MONITORING YEAR 0 ANNUAL REPORT

COOL SPRINGS MITIGATION SITE

DMS Project No. 100166
NCDEQ Contract No. 0302-02
DMS RFP No. 16-20190302/Issued: December 20, 2019
USACE Action ID No. SAW-2020-01400
DWR Project No. 2020-1279

Subject: DMS Comments on the MY0 and As-built/Record Drawings
DMS Project Number 100166
Harnett County, North Carolina
DMS Contract Number 0302-02

1.5.1

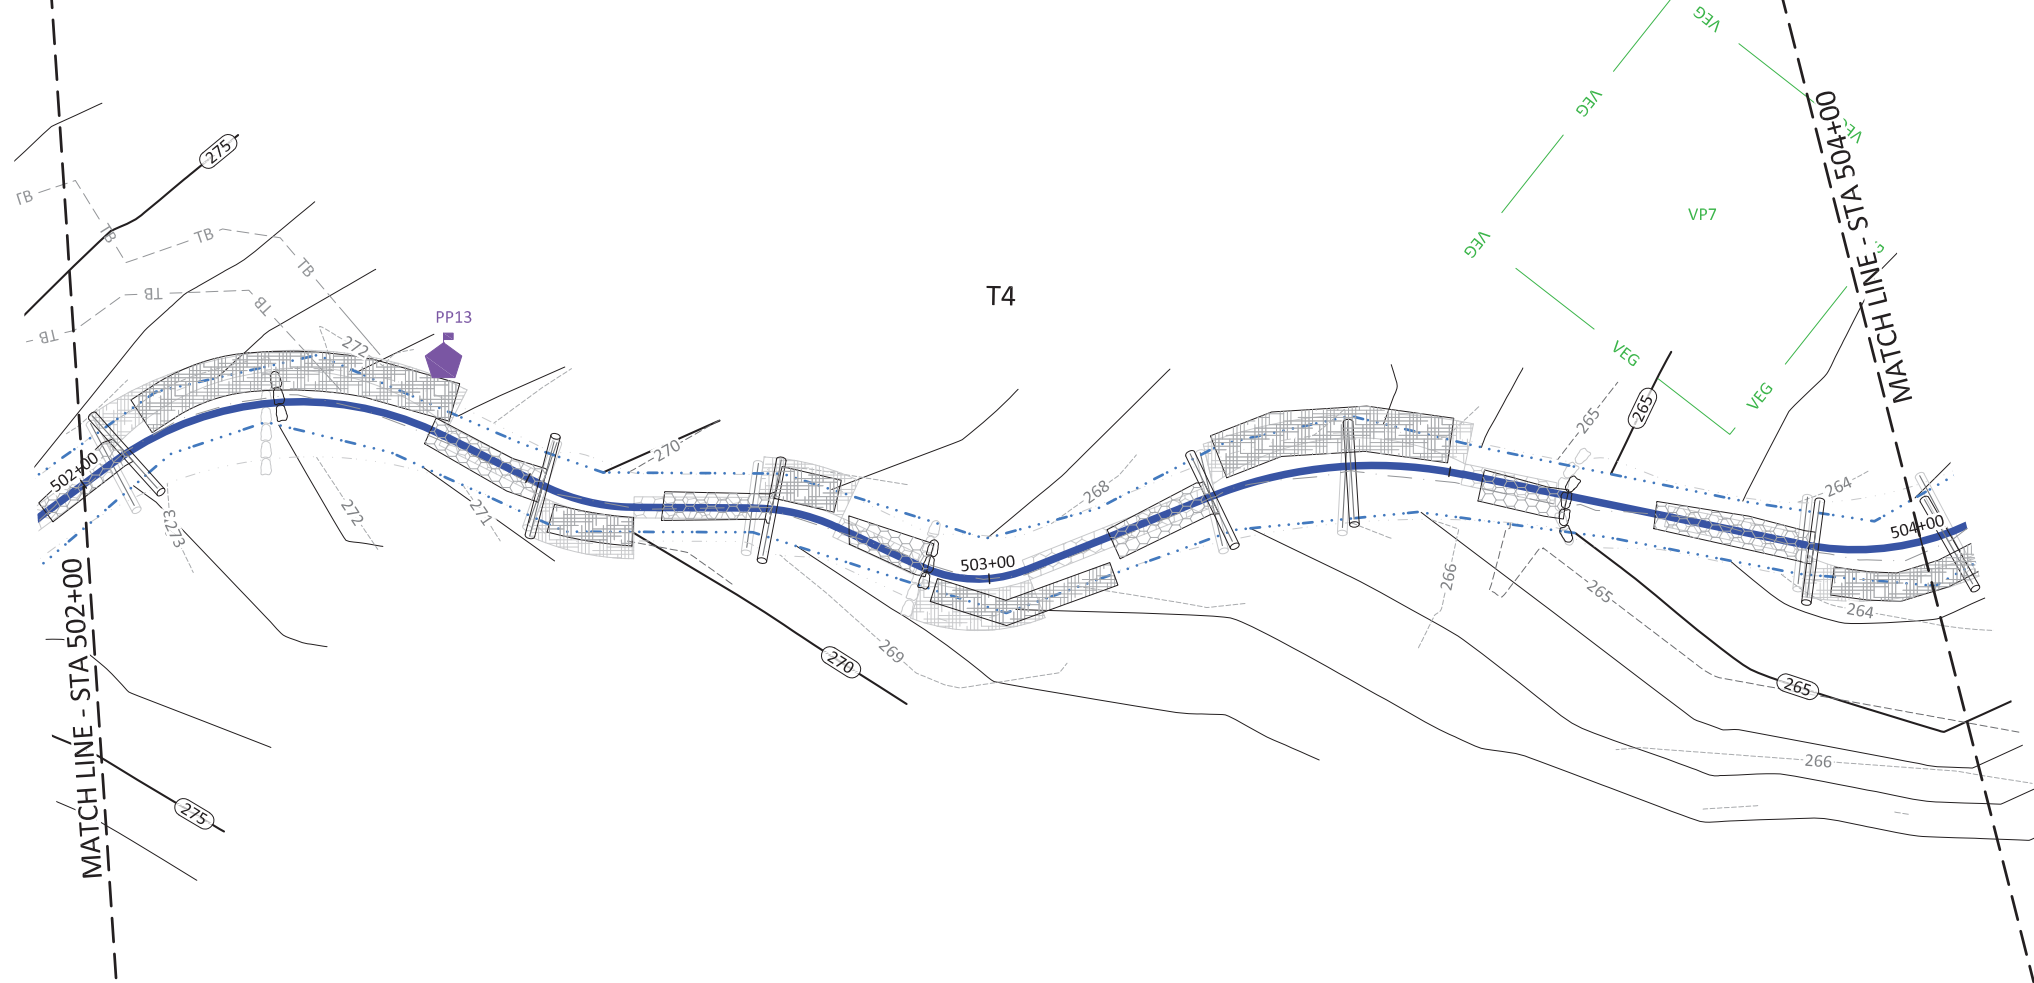
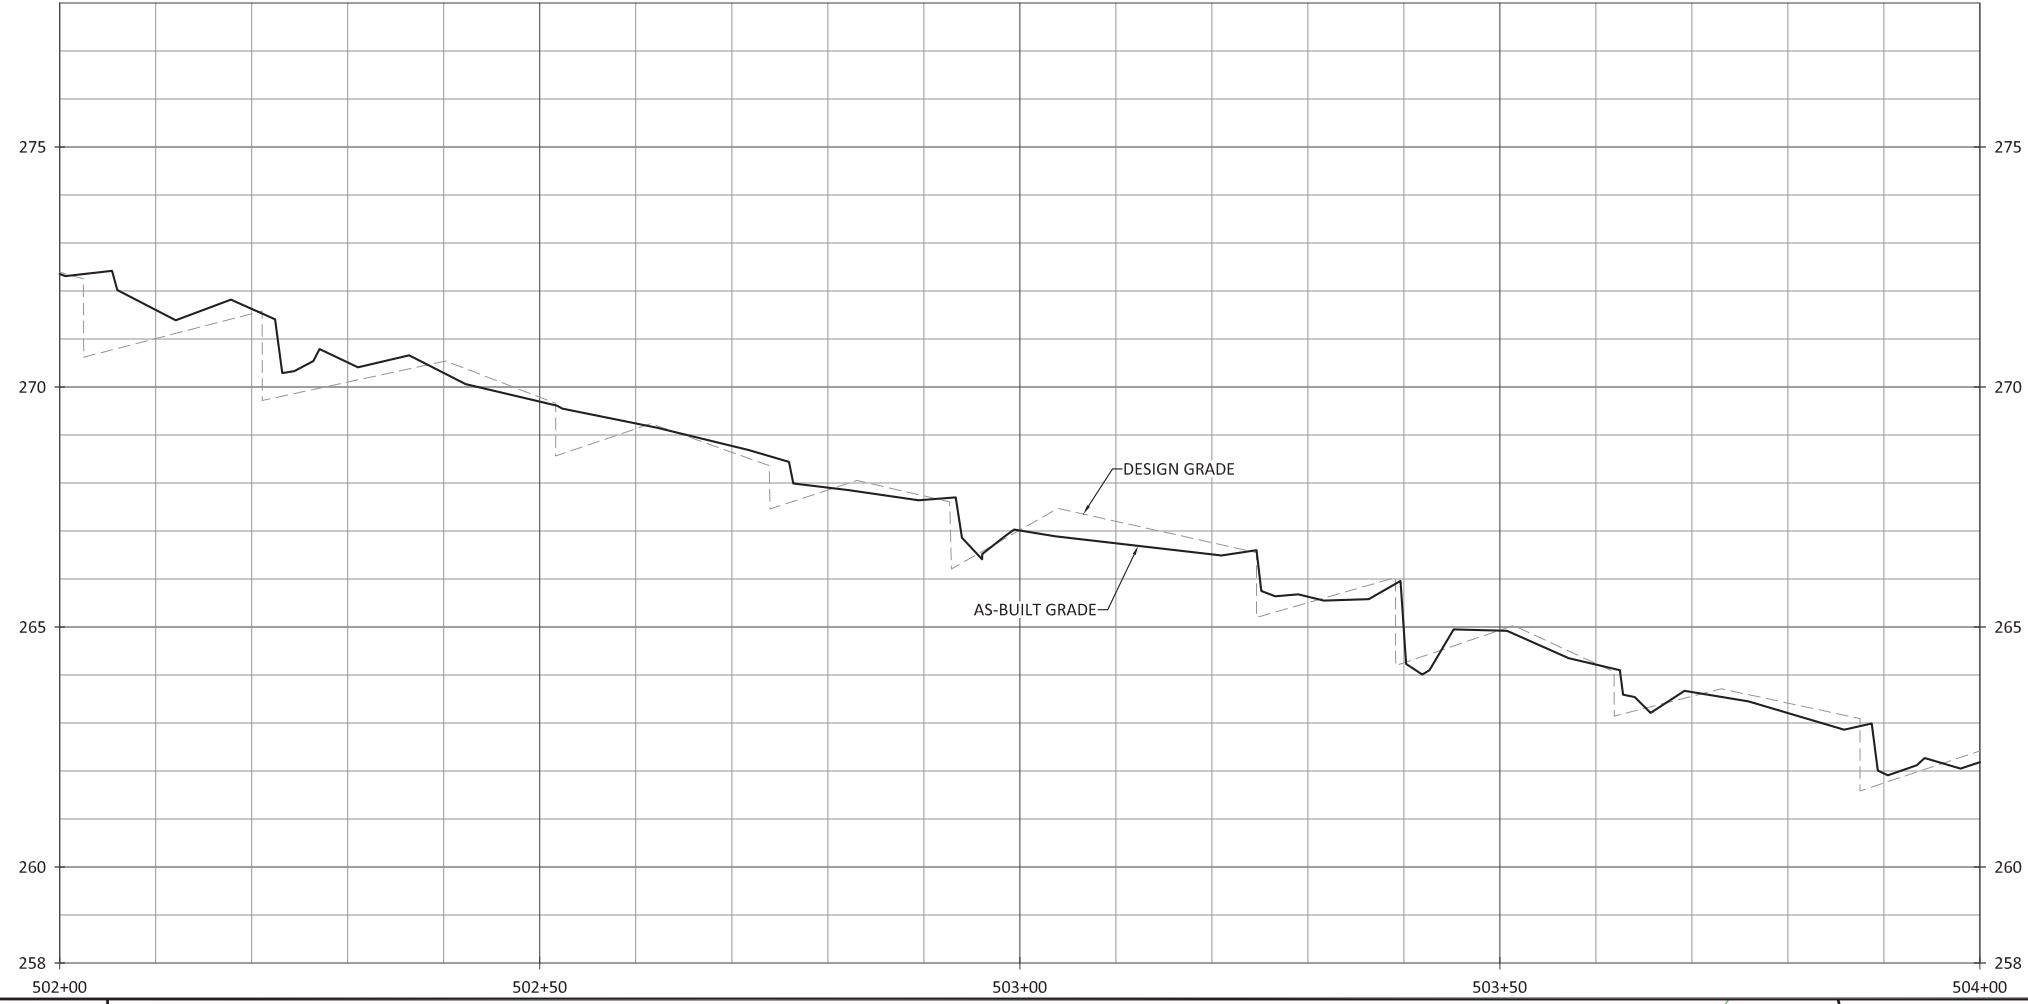
6. A riffle on T4 (see Sheet 1.5.1) in the vicinity of STA 501+00 was determined during the site visit to have not been installed and should be called out.

After verification with the Construction Admin for Cool Springs, the riffle on T4 at Station 500+89 – 501+03 was constructed, but some of the riffle material has washed away. However, the riffle was determined to be stable, and no repair is needed. The record drawings have been updated to reflect this.

1.7.1

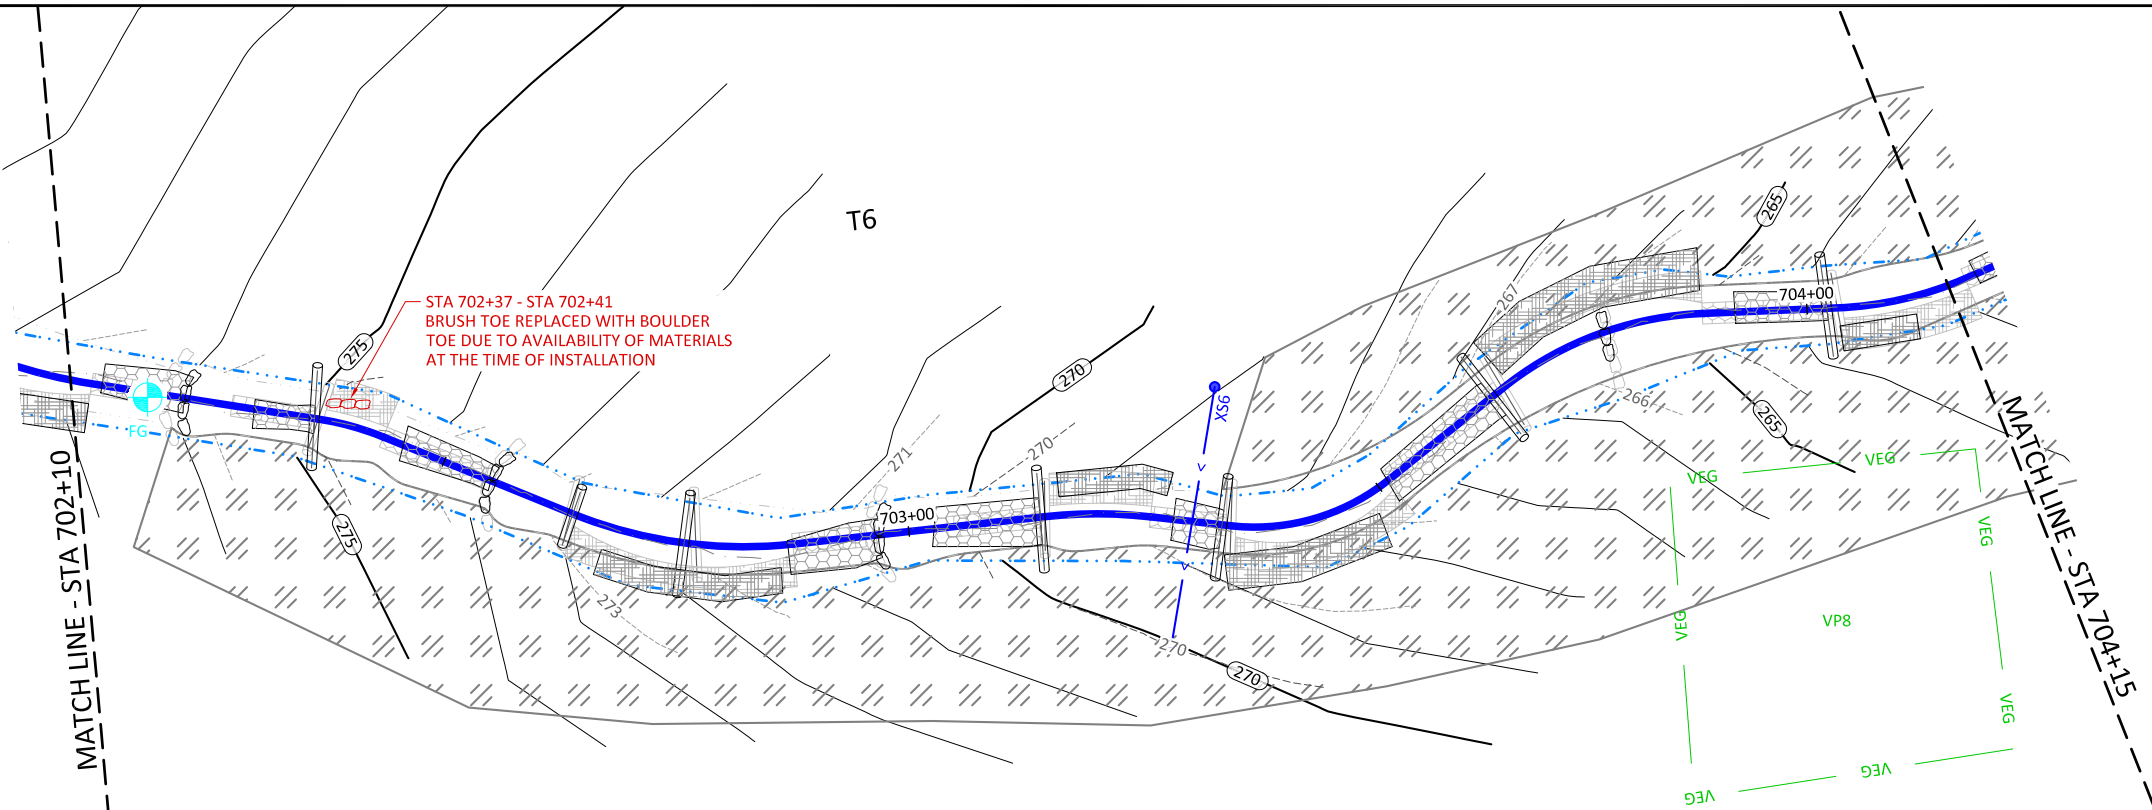
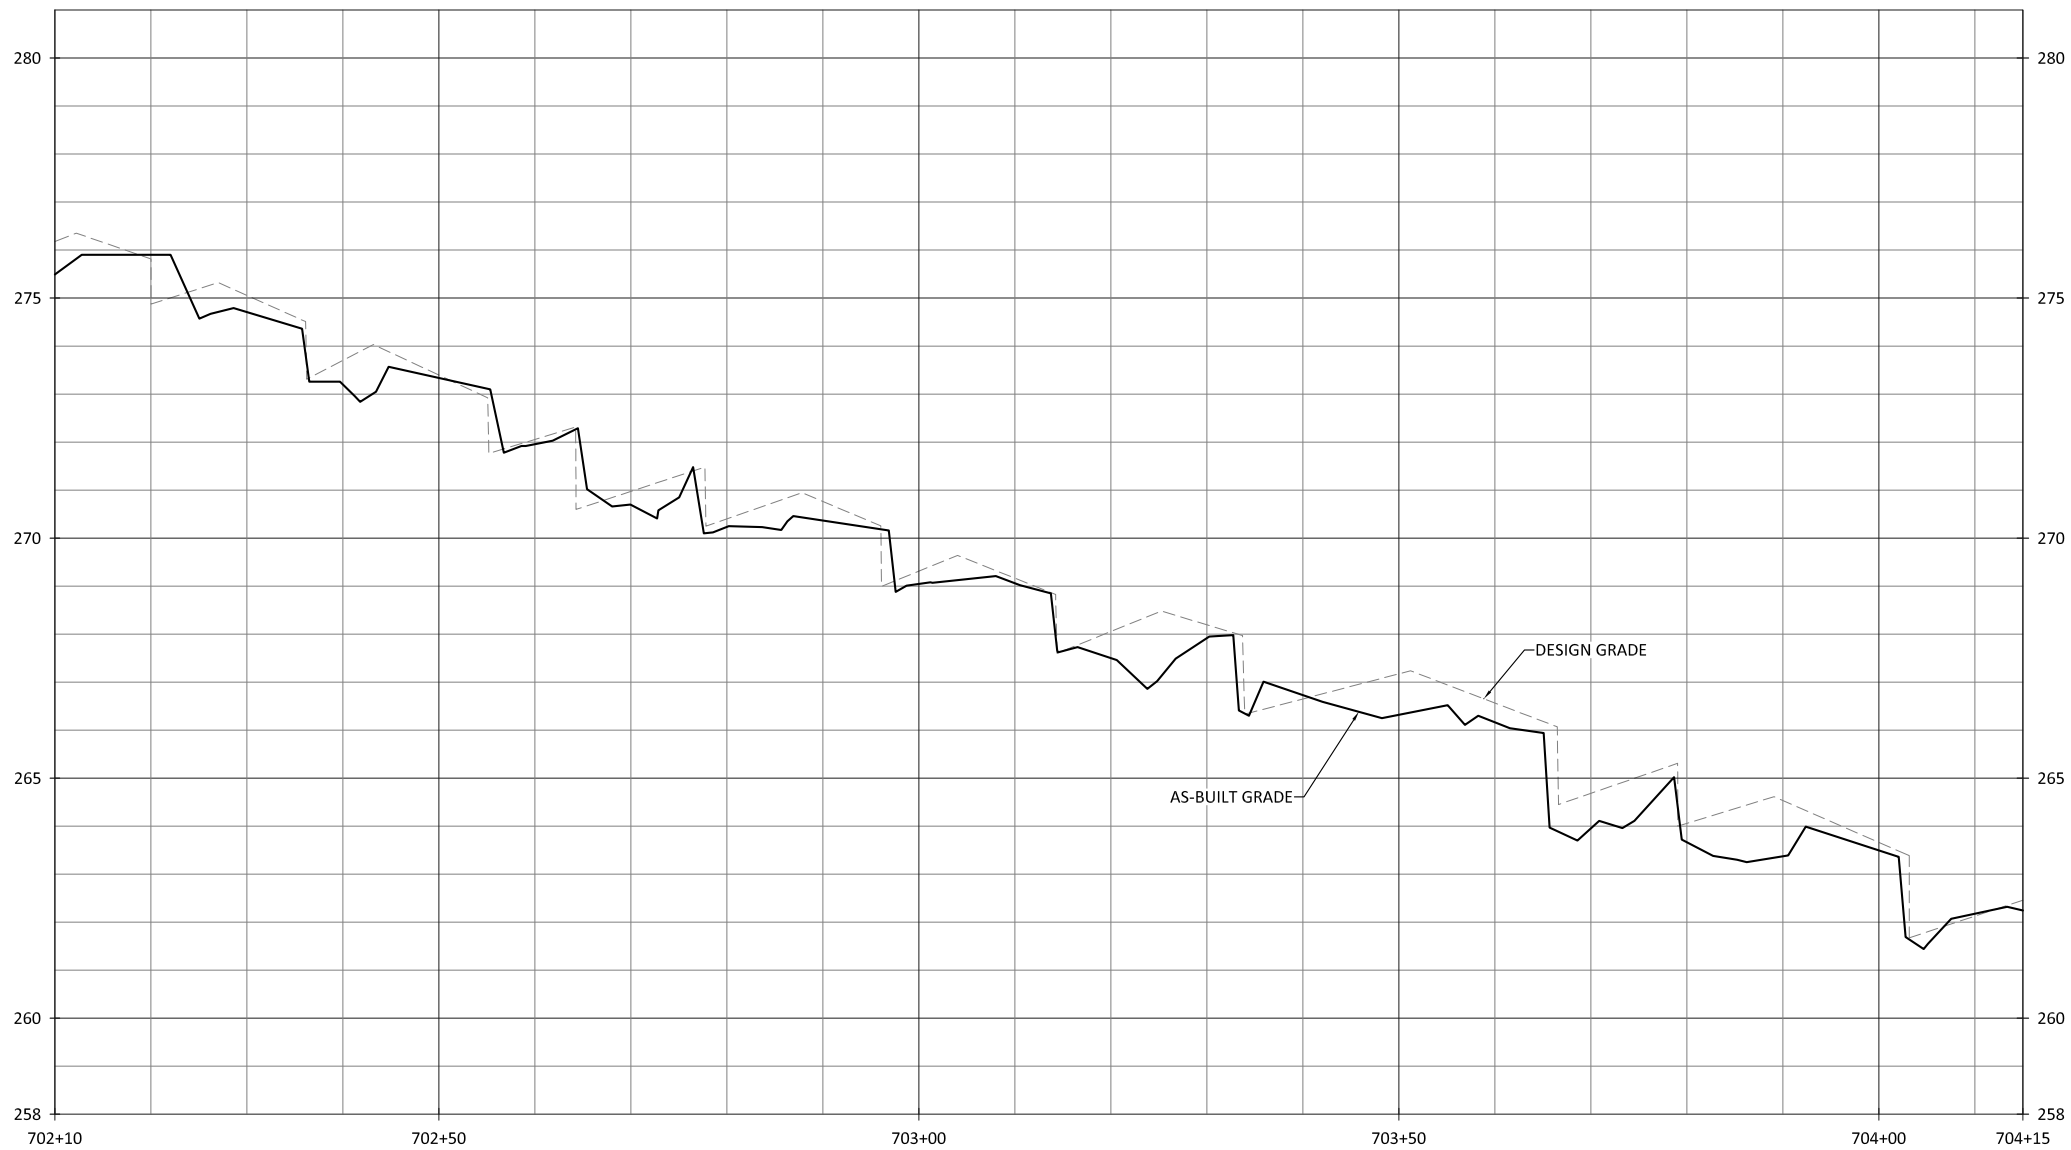
7. On T6 (see Sheets 1.7.1. & 1.7.2) log sills at STA 702+03 and STA 702+64 were called out as replaced with a boulder sill, but field observations during the visit indicate that the log sills were installed as designed. Please remove these callouts from the drawings and section 2.1.11.

The callouts on record drawing sheets 1.7.1 and 1.7.2 and report section 2.1.11 referencing log sill replacement at STA 702+03 and STA 702+64 have been removed.
